LEGAL NOTICE EXETER PLANNING BOARD AGENDA

Date: June 24, 2021
To: Planning Board
From: Dave Sharples, Town Planner
Re: Phillips Exeter Academy PB Case #21-5

Re: Site Plan Review TRC Comments - Phillips Exeter Academy
PB Case #21-5
Tax Map Parcel #94-19

SHEET NUMBER: C-2

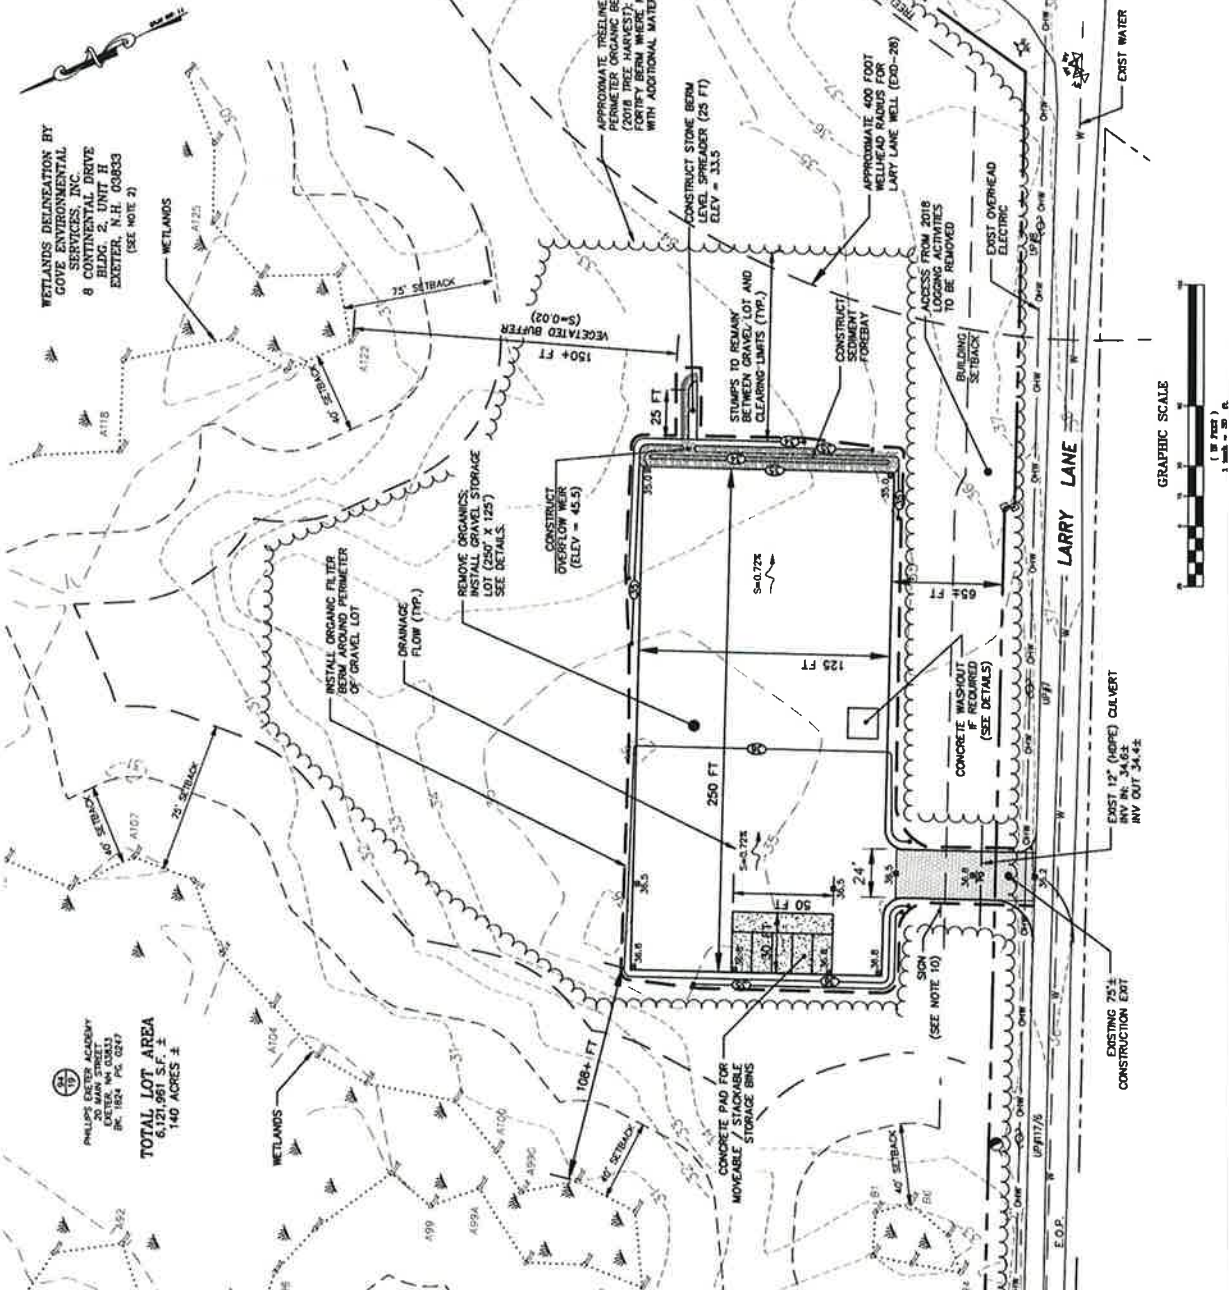
2. The approximate location of Exeter's Lary Lane Well (water supply) and its corresponding 400' well radius should be shown on the plans. Please note on the plans that the project area is within the wellhead protection area.

3. An area designated for a concrete washout pit should be indicated on the plan.
4. If within the plan viewport, please incorporate the Lary Lane Well and the 400' protective well radius in the plan.
5. The material and inverts of the existing driveway culvert should be labeled.

of the Lary Lane Well and the 400 foot well radius, based on GIS and aerial imagery. The project is within the wellhead protection area and the Aquifer Protection Overlay District. The well location, radius, and Aquifer Protection Overlay District have been noted on the plans.

A concrete washout area has been added to the plan and detail provide.

The Lary Lane Well and 400 foot radius have been added to the plans.

The culvert material and approximate inverts have been added to the plan.
